### Inland Transport Committee

#### Regulation No. 11 (Door latches and hinges)

## Proposal for the 04 series of amendments to Regulation No. 11

### Submitted by the expert from the European Commission\*

”Annex 2

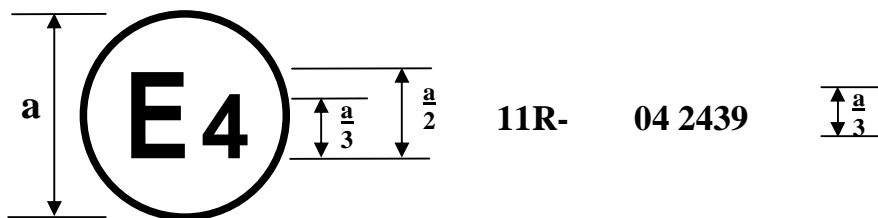
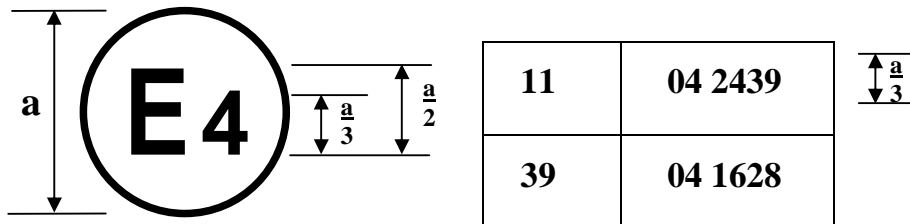
The above approval mark affixed to a vehicle shows that the vehicle type concerned has, with regard to door latches and door retention components, been approved in the Netherlands (E 4) pursuant to Regulation No. 11, under approval number 042439. The first two digits of the approval number indicate that the approval was granted in accordance with the requirements of Regulation No. 11 as amended by the 04 series of amendments.

The above approval mark affixed to a vehicle shows that the vehicle type concerned has been approved in the Netherlands (E 4) pursuant to Regulation No. 11 as amended by the 04 series of amendments and Regulation No. 39, as amended by the 04 series of amendments. 1/”

**Figure 7-1**

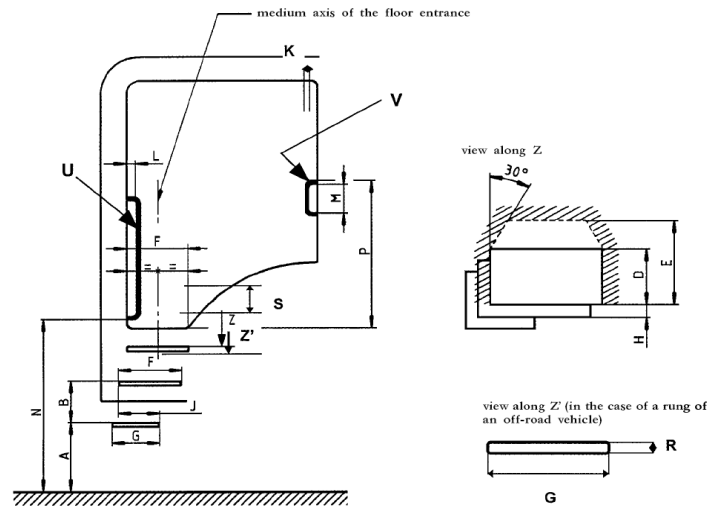
- 1. Access steps to the driver's compartment (see figure 7-1)**
- 1.1. The distance (A) from the ground to the upper surface of the lowest step, measured with the vehicle in running order on a horizontal and flat surface, shall not be more than 600 mm**

- 1.2. The distance (B) between the upper surfaces of the steps shall be not more than 400 mm. The vertical distance between two subsequent steps shall not vary by more than 50 mm. The last requirement shall not apply to the distance between the uppermost step and the cab floor.**

- 1.3. In addition, the following minimum geometrical specifications shall be fulfilled:**
  - (a) step depth (D): 80 mm**
  - (b) step clearance (E) (include step depth): 150 mm**

- (c) step width (F): 300 mm**
  - (d) width of the lowest step (G): 200 mm**
  - (e) step height (S): 120 mm**
  - (f) transversal offset between steps (H): 0 mm**

- (g) longitudinal overlap (J) between two subsequent steps in the same flight, or between the uppermost step and the cab floor: 200 mm.**
- 1.3.1. However, for off-road vehicles (see paragraph 1.1.1.) the value (F) may be reduced to 200 mm.**

- 
2. Access to handholds to the driver's compartment (see figure 7-1)
    - 2.1. One or more suitable handrails and handholds or other equivalent holding devices shall be provided for the access to the driver's compartment.

- 2.1.5. The steering wheel may be considered as a handhold.
    - 2.2. The height (N) of the lower edge of at least one handrail or handhold or equivalent holding device, measured from the ground with the vehicle in running order on a horizontal and flat surface, shall not be more than 1,850 mm.

- 2.2.3. In addition, the minimum distance (P) of the upper edge of the handrail(s) or handholds or equivalent holding devices from the floor of the driver's compartment shall be:

- (a) handrail(s) or handholds or equivalent holding devices (U) 650 mm,
        - (b) handrail(s) or handholds or equivalent holding devices (V) 550 mm.

- 2.3. The following geometrical specifications shall be fulfilled:
      - (a) gripping dimension (K): 16 mm minimum 38 mm maximum,
      - (b) length (M): 150 mm minimum,

- (c) **clearance to vehicle components (L): 40 mm minimum with open door.**
